REMIX COLLECTIONS LTD

18 November 2025

1. Building Information

Observation-02: Possible horizontal and vertical extension (Production Building).

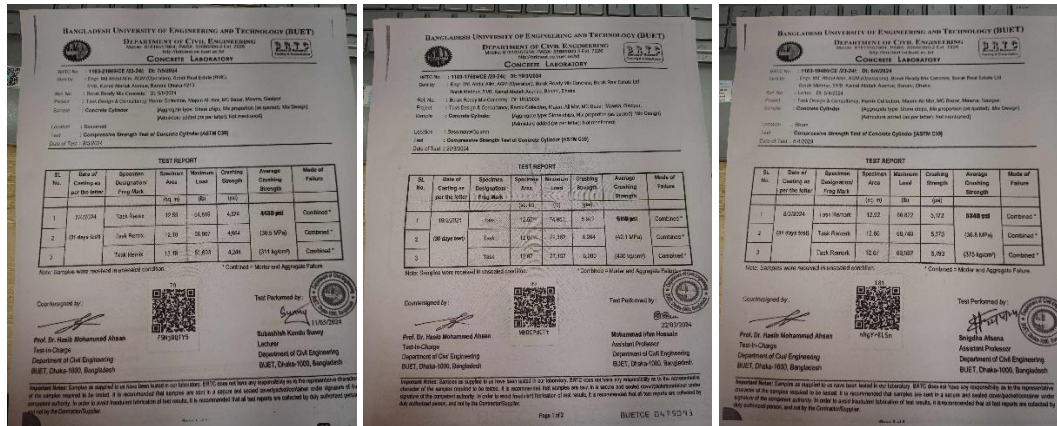
Description: Some exposed rebar was found on the roof and projected horizontally, which indicates the possibility of future extension. The factory has a plan to conduct the future extension. The building is currently single-storied but is proposed as a five-story building, as per the local authority permit drawing. Before conducting any future extension, prepare a Detailed Engineering Assessment (DEA) and submit it to RSC for review.

2.		Implement remediation work if required.	within 6 months
3.	Possible horizontal and vertical extension (Production Building).	The building engineer is required to prepare a Detailed Engineering Assessment (DEA) report prior to conducting any horizontal or vertical expansion.	within 6 weeks

4.		The building engineer is required to follow the construction safety measures during the commencement of further extension work.	within 6 months
5.	Inadequate number of concrete cylinder test reports (Production Building).	The building engineer is required to take a minimum 4- 100mm diameter concrete core from structural elements (column and beam/slab).	within 6 weeks
